MICHIGAN CAT PUMP AND SHORE MAINTENANCE YARD JSP23-47

Consideration of Preliminary Site Plan, Stormwater Management Plan, and Woodland Permit approval at the request of Michigan CAT for an addition of a paved outdoor storage area to the existing Michigan CAT site. The subject property totals 32.39 acres but the affected area is 5.29 acres and is part of an approved PRO. The subject property is located north of Ten Mile Road, on the east side of Novi Road. The approved PRO rezones the portion of the parcel from Light Industrial (I-1) to General Industrial (I-2). The project requires a woodland permit for 47 woodland replacement credits, with 15 replacement proposed to be planted onsite and a donation to the tree fund for the remaining 32 credits.

PLAN REVIEW CENTER REPORT

Review Date: November 8, 2023
Review Type: Combined Preliminary and Final Site Plan Review
Project Name: MI CAT Pump and Shore Maintenance Yard
Location: 24800 Novi Road; 22-23-351-065
Plan Date: October 19, 2023
Prepared by: James Hill, Planner
Contact: E-mail: jhill@cityofnovi.org Phone: 248.347.0547

Drawing Number
C100

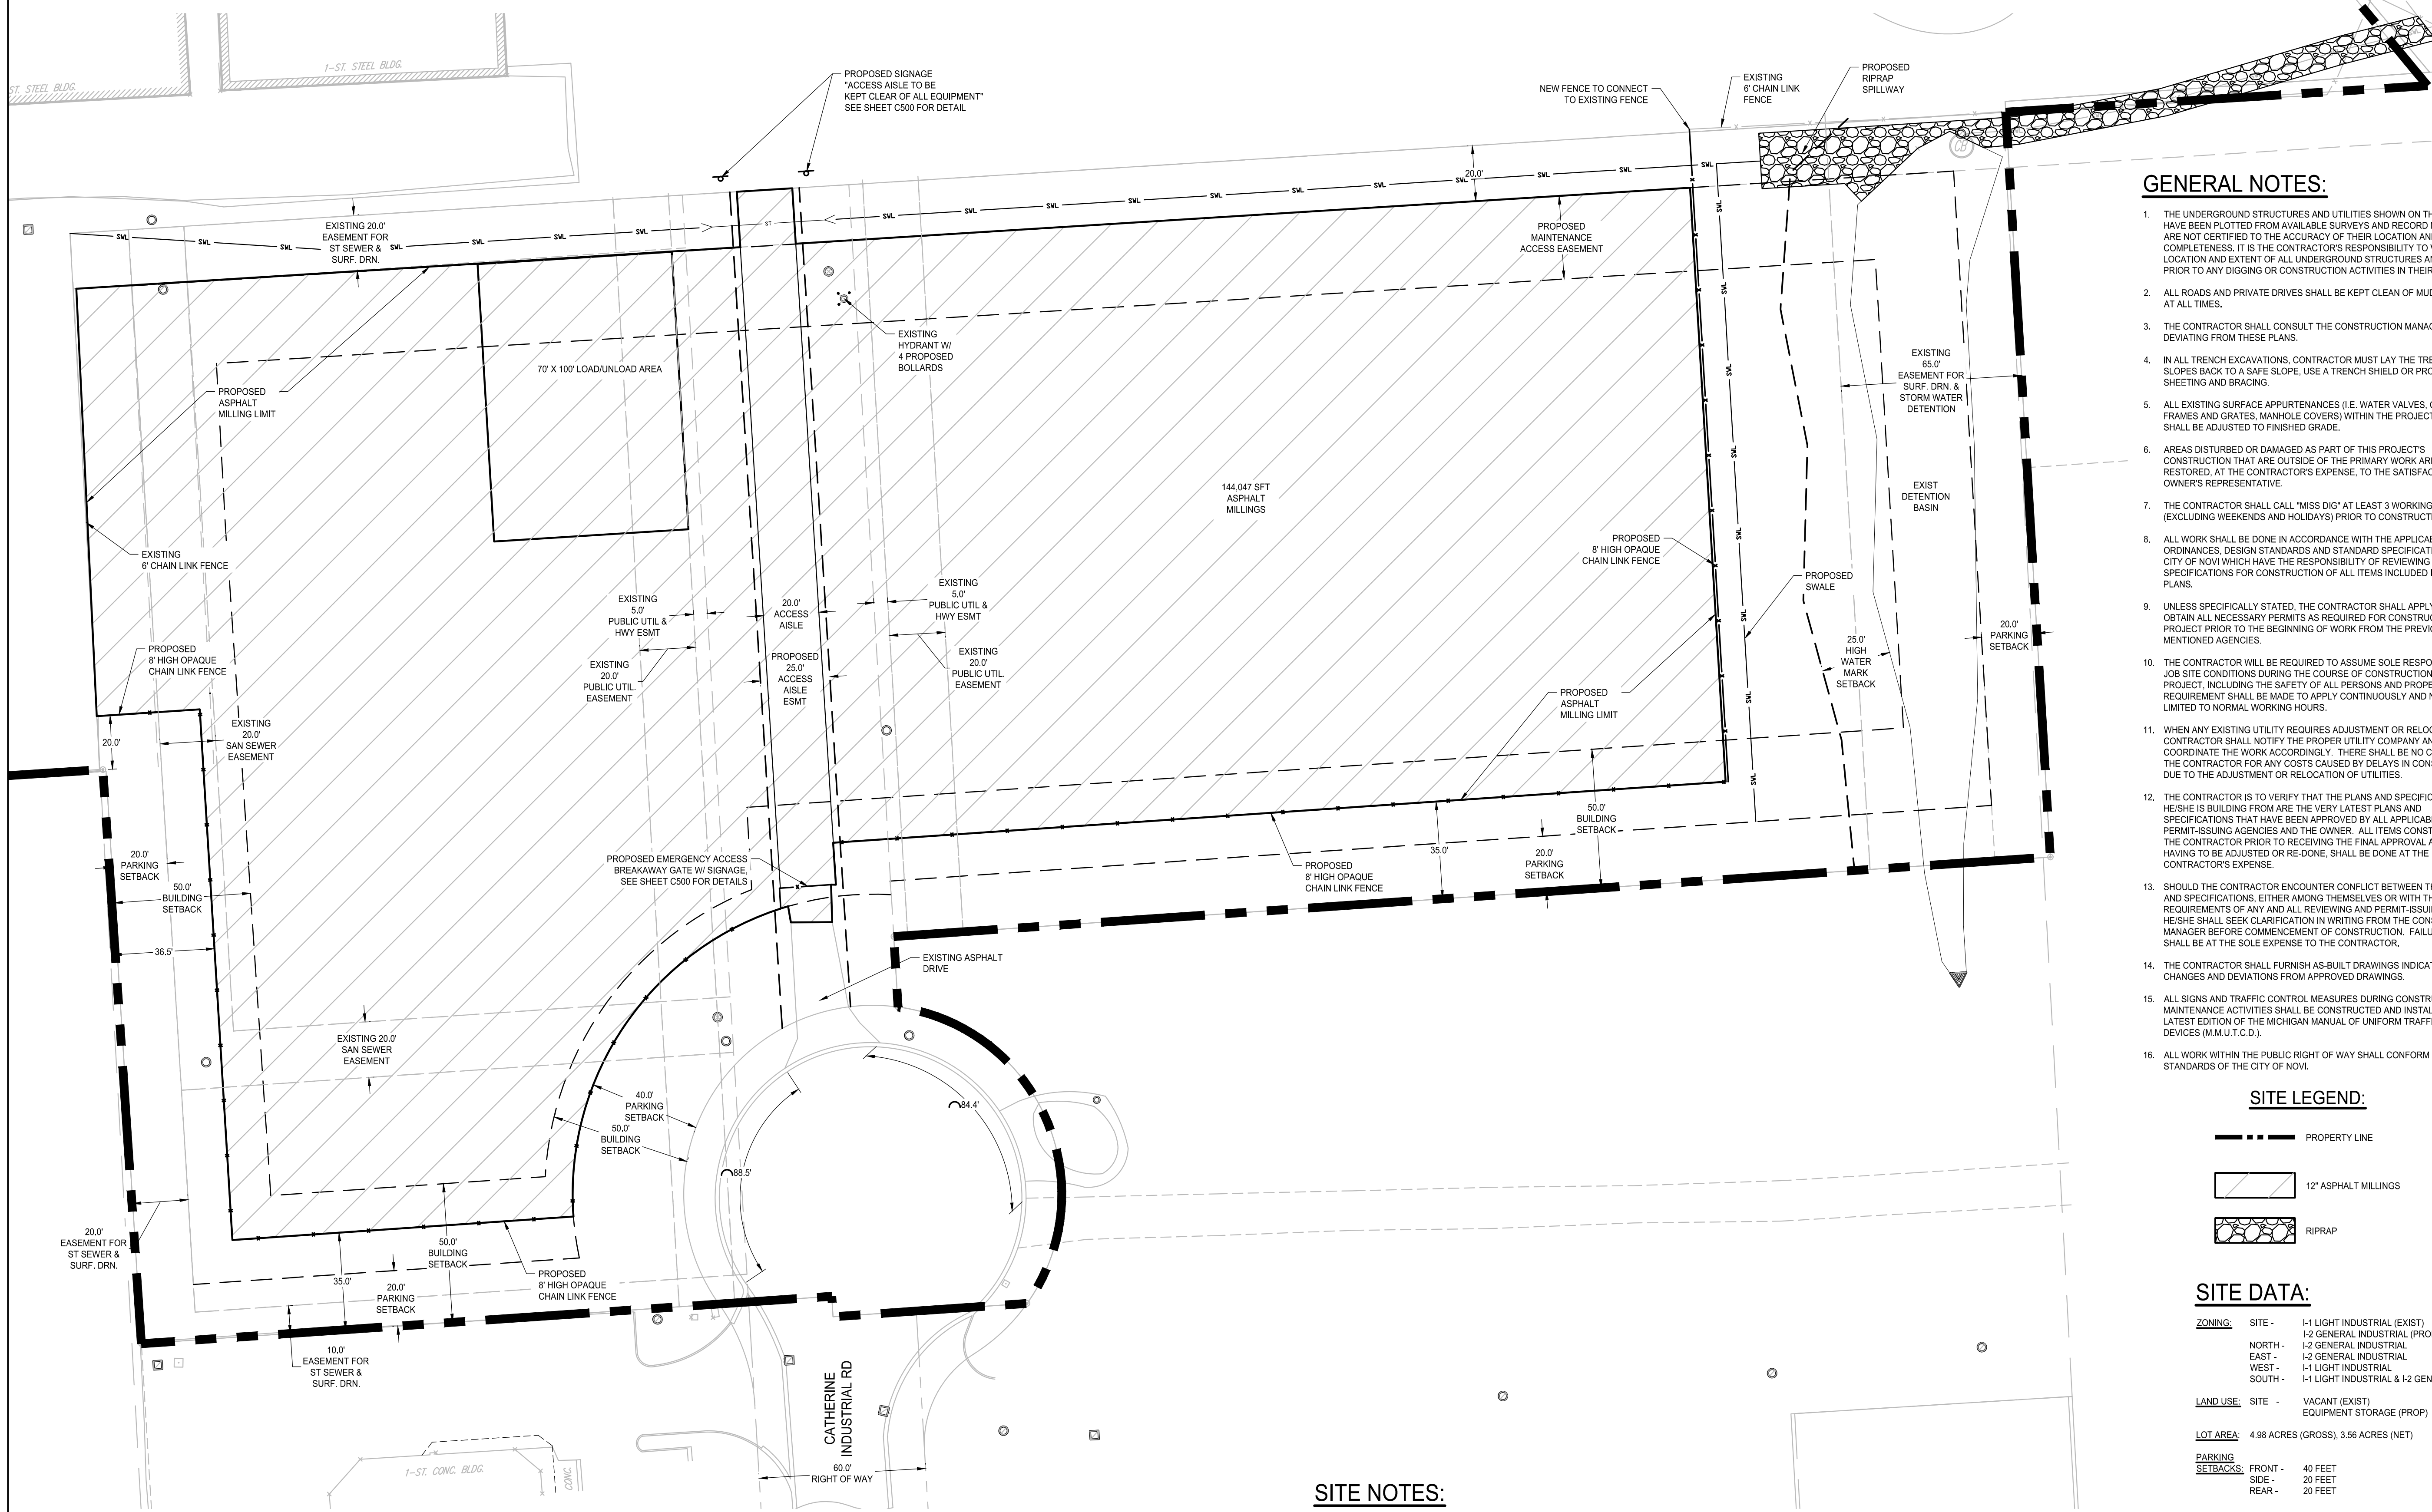
5. The plans show Munro Creek, however it is the Walled Lake Branch of the Middle Rouge. Revise the plans accordingly.
6. On the soil erosion plan sheet C140, silt fence should be installed beyond the area of disturbance, and the silt fence should be extended to include the riprap area.

4. We cannot confirm the easements shown on the plan have been recorded. Please clarify and add the Liber and Page. **Noted.**
5. The plans show Munro Creek, however it is the Walled Lake Branch of the Middle Rouge. Revise the plans accordingly. **Sheet C100 will change from Munro Creek to Walled Lake Branch of the Middle Rouge.**

C110

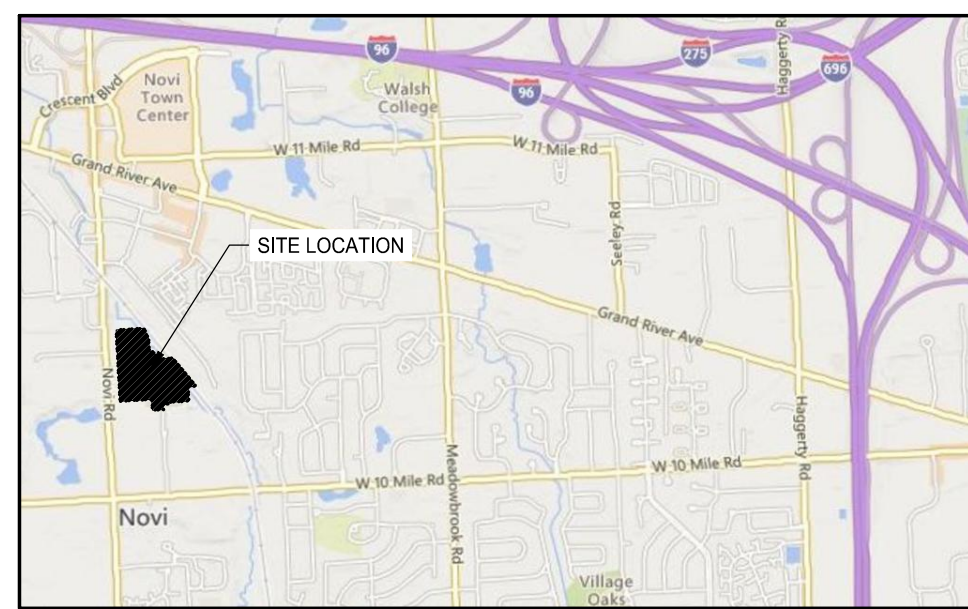
1. Label/call out the proposed bollards around the existing hydrant on sheet C110 (already noted on sheet C101).
2. **Only at the time of the printed Stamping Set submittal**, provide the City's standard detail sheets for paving (2 sheets). The most updated details can be found on the City's website under [Engineering Standards and Construction Details](#).

7. Confirm the required rim adjustments required, and revise as appropriate. Multiple locations propose a 0.02' adjustment, and one location did not appear to match the elevation of the proposed grades.

11. Provide a construction materials table on the paving plan listing the quantity and material type for the millings cross section being proposed.
12. The plans shall show the hydrant and gate well adjustments as appropriate.
13. A12 inch depth of millings is noted on plan. However, also provide a detail showing the cross section, including soil preparation/compaction, gradation of millings, and any other applicable information.
14. Per MDOT Special Provision for Crushed Concrete, the use of crushed concrete is prohibited on the project within 100 feet of any water course (stream, river, county drain, etc.) and lake, regardless of the application of

1. Label/call out the proposed bollards around the existing hydrant on sheet C110 (already noted on sheet C101). **Proposed bollards will be called out on sheet C110.**

7. Confirm the required rim adjustments and revise as appropriate. Multiple locations propose a 0.02' adjustment, and one location did not appear to match the elevation of the proposed grades. **Existing and proposed rim elevations will be confirmed and revised where applicable on sheet C110.**

- a. The existing basin outlet structure appears to be clogged/sedimented and must be cleaned. **Note on sheet C110 will be added, instructing contractor to expose and clean existing outlet structure.**

- b. Show the existing grading from the outlet structure to the Rouge River on the plans (this was previously shown on the topographic survey from Warner Cantrell). **Sheet C110 will be enlarged to show existing grading from proposed site to the banks of the Middle River Rouge.**

12. The plans shall show the hydrant and gate well adjustments as appropriate. **Existing and proposed elevations will be shown for both on sheet C110.**

SESC DETAILS
Drawing Number
C141

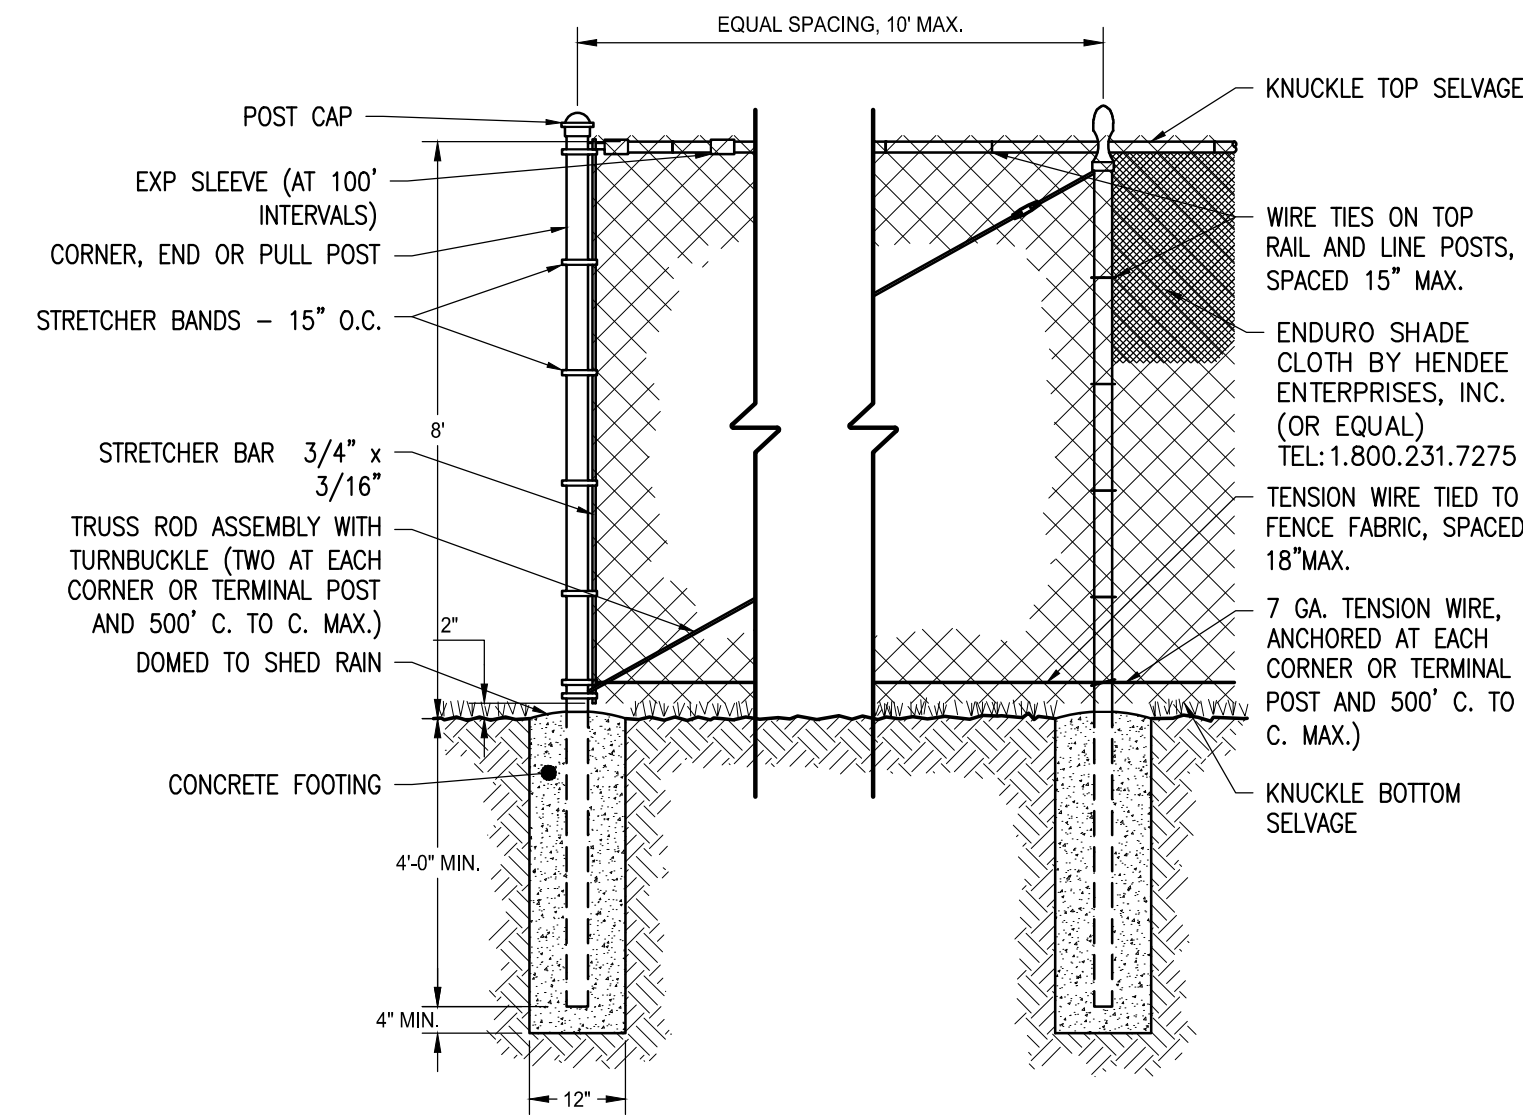
1. A survey and chart are provided.
2. 47 woodland replacement credits are required. 15 replacement trees are proposed to be planted west of the detention pond. A donation to the tree fund will be made for the remaining 32 required credits.
3. Please add a tree protection fence detail to Sheet C141 of the Civil Plans.

6. On the soil erosion plan sheet C140, silt fence should be installed beyond the area of disturbance, and the silt fence should be extended to include the riprap area. **Silt fence will be moved to the outside of the limits of disturbance and extended to the Walled Lake Branch of the Middle Rouge**

7. Please number the topo sheet consistently with the other sheets. **Sheet C010 will be numbered to match the rest of the set.**
8. Please add an irrigation plan or information as to how plants will be watered sufficiently for establishment and long- term survival. **Irrigation plan to be provided at Final Site Plan**
9. Please add the tree protection fence detail (below) to Sheet C141. **Detail will be placed on Sheet C141.**

C500

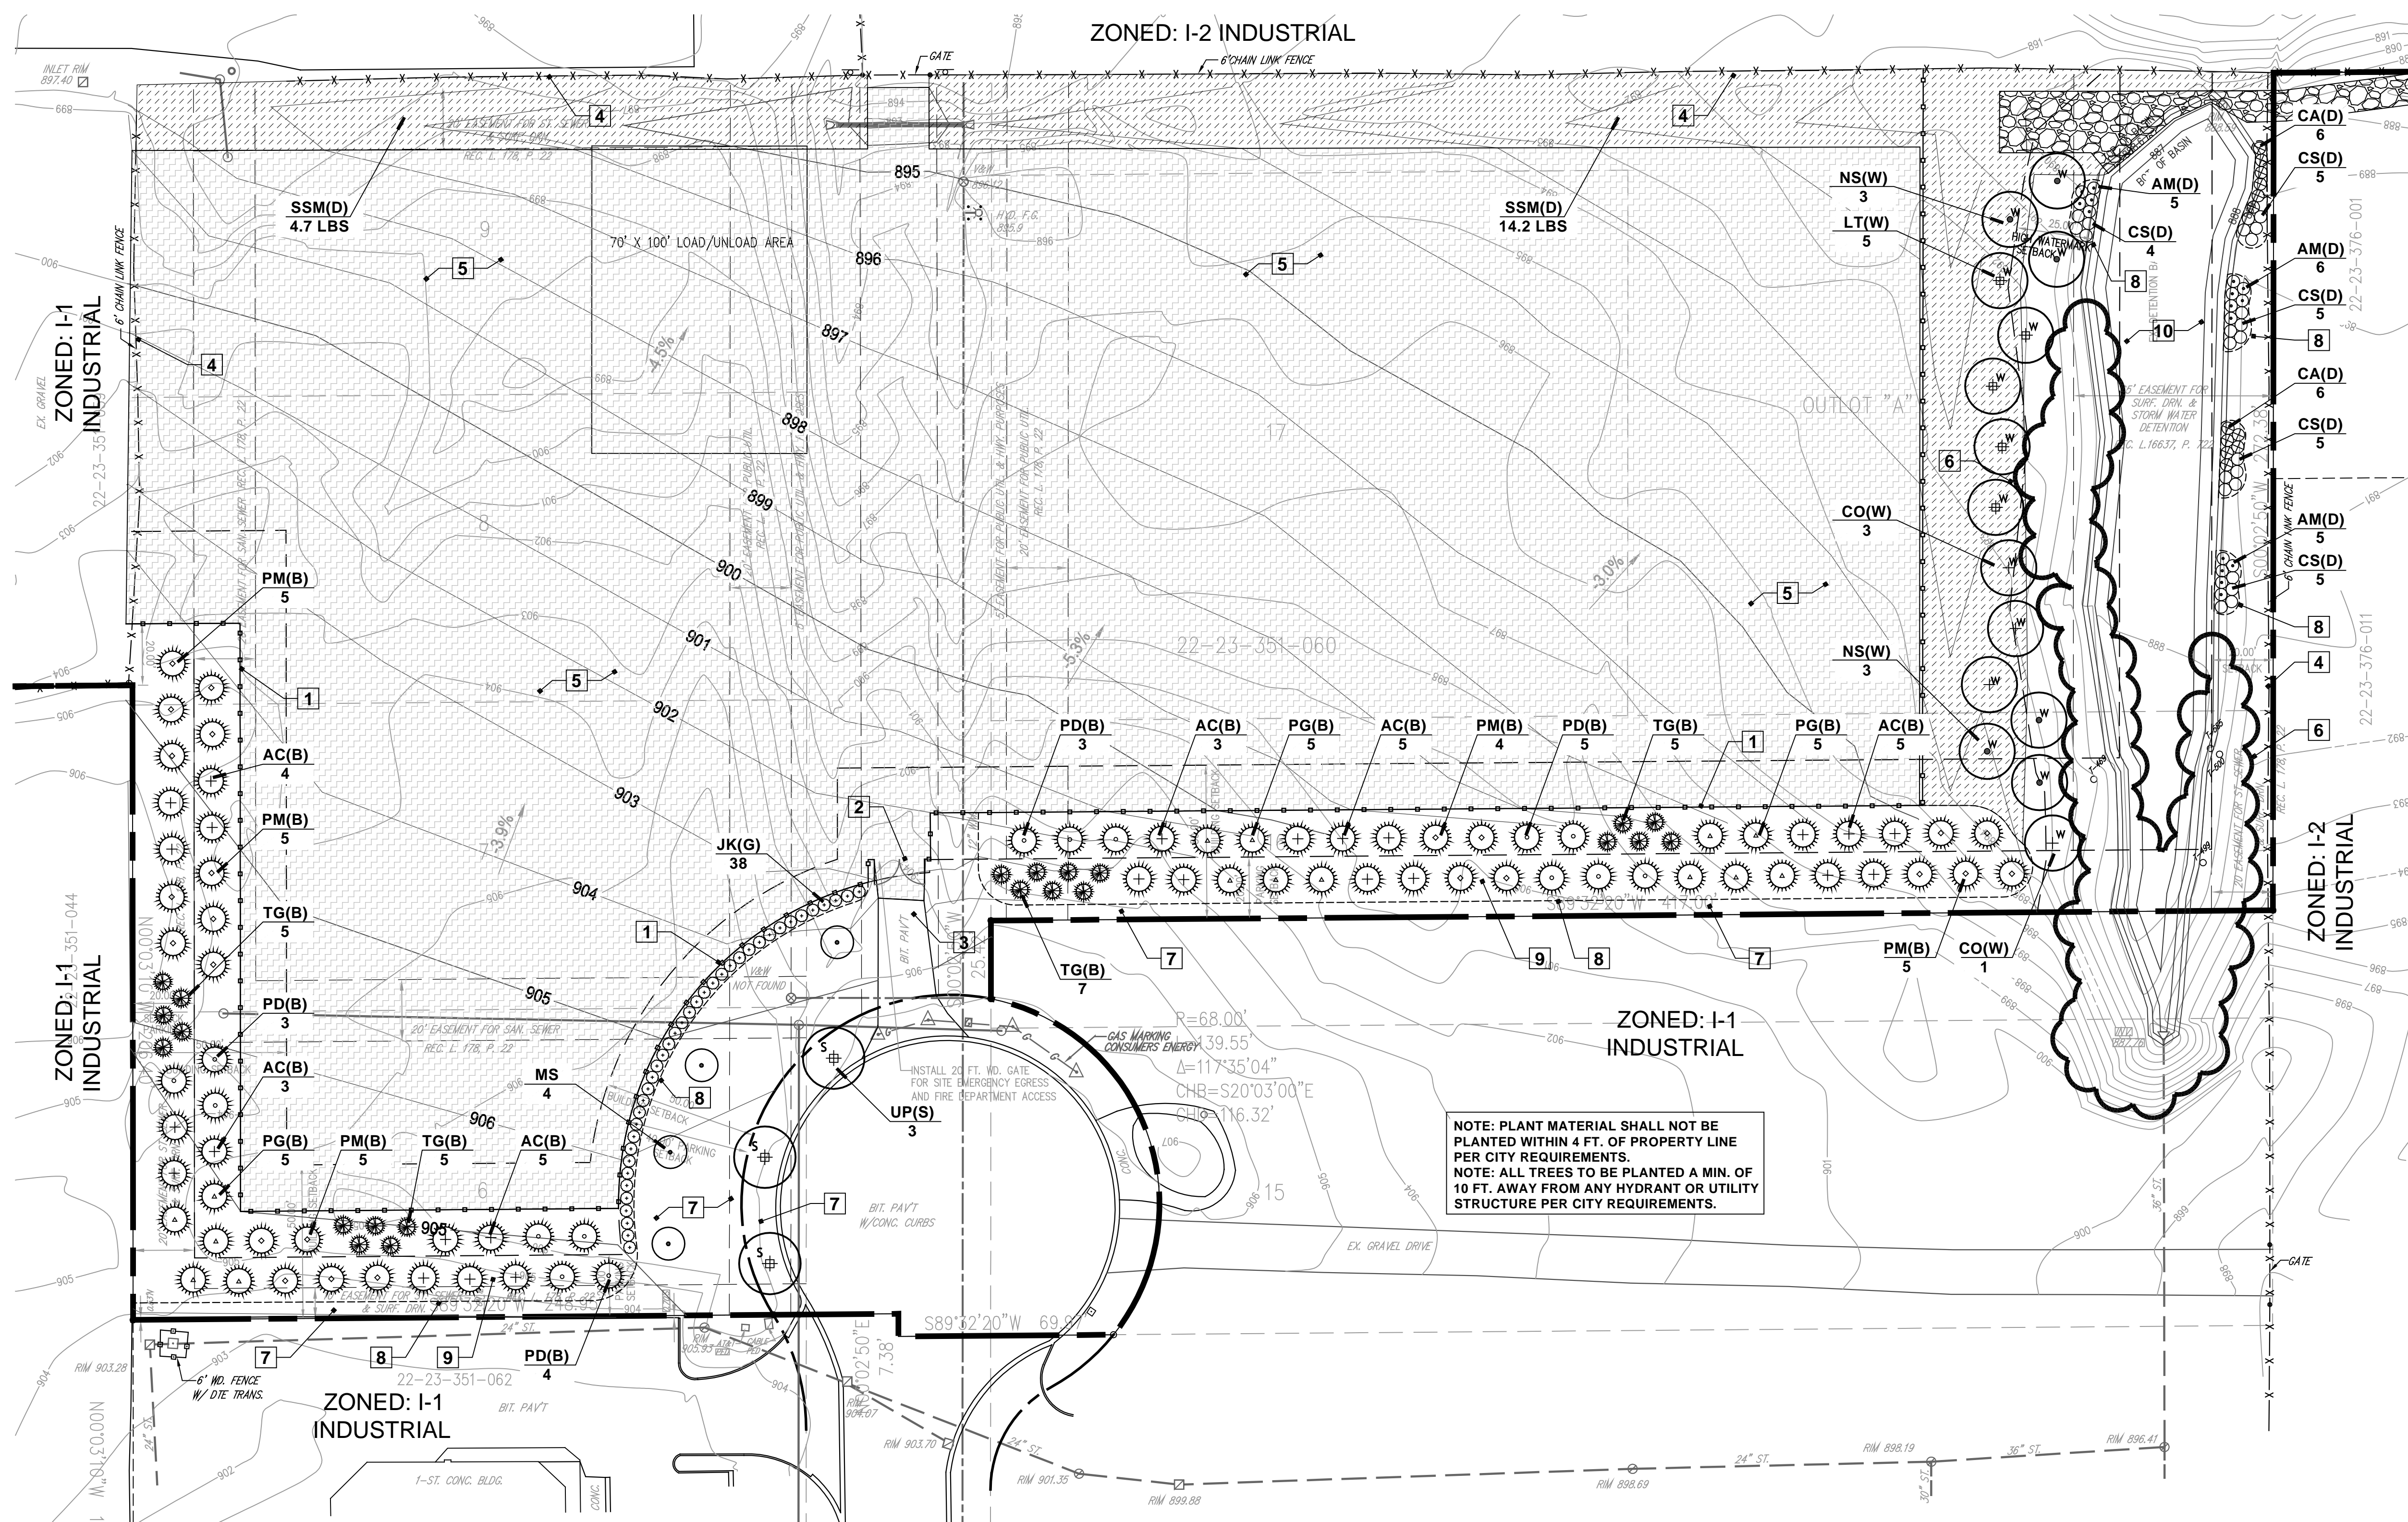
3. Provide a traffic control sign table listing the quantities of each **permanent** sign type proposed for the development.
4. We cannot confirm the easements shown on the plan have been recorded. Please clarify and add the Liber and Page.

3. Provide a traffic control sign table listing the quantities of each permanent sign type proposed for the development. **Traffic control sign table will be listed on sheet C500.**
